National Transportation Safety Board

Safety Recommendation

In reply refer to: A-94-190

On April 2, 1994, about 1439 eastern standard time, a Boeing 727-243, N59412, operating as Continental Airlines flight 1447, landed at Orlando International Airport with the left main landing gear partially extended. The airplane came to rest on the left wing leading edge slats, trailing edge flaps, wing tip, nose tires, and right main landing gear. None of the nine crewmembers or 141 passengers were injured. Examination of the airplane revealed that the left main landing gear was in the wheel well, resting on the main landing gear door. A broken door fitting was found lodged in the door hinge area.

DOOR COMPONENTS

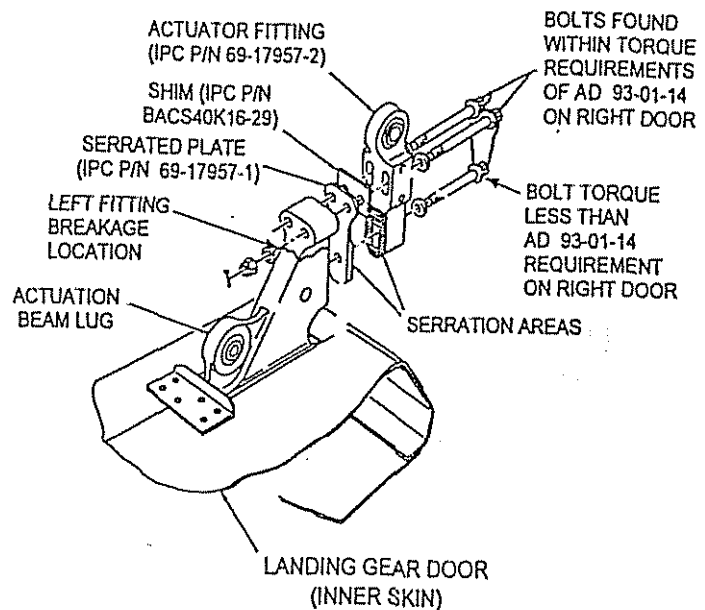
The left main landing gear door fitting assembly laminated shims were removed and found degraded. The rectangular shims were distorted in shape, the individual plies were shifted, and the bolt holes were elongated. Degradation of the shims prevented a determination of their thickness prior to the incident.

At the Safety Board's laboratory, investigators found that loosening the single outboard bolt and not filling the shim pocket caused the left steel fitting and serrated plate on the damaged serrations at the base of the fitting pocket to pivot. Pushing the walls of the pocket toward each other caused separation of the serrated surfaces near the single outboard bolt.

Because of the damage to the left door fitting assembly, the serviceable right door actuator fitting assembly was also examined. The right fitting single outboard bolt was found to have slightly less than the required torque. Evidence of fretting was seen at the edges of the fitting teeth and light could be seen between the aluminum fitting and the serrated plate. Shims removed from the right door fitting assembly were found to be distorted, with bolt hole elongation and shifting of the laminated plies. The shims in the right door fitting had degraded to the point of extruding from the assembly.

Serration damage seen in the left fitting, fretting residue found in the right fitting, extrusion of shim material, and shifting of plies indicated that the fitting assemblies had not been stable before the incident. Insufficient torque of the fitting bolts and loss of shim material may have loosened the actuator fitting bolts.

Revise Airworthiness Directives 90-02-19 and 93-01-14, applicable to Boeing 727 main landing gear door actuator fitting assemblies, to reduce the current inspection intervals, thereby improving the potential for identifying loose bolts and cracks in the aluminum fittings. The revision should also require inspection of the laminated shims within the assembly for reduction of thickness and degradation and require continued periodic inspections until an alternative design is available. (Class II, Priority Action) (A-94-190)
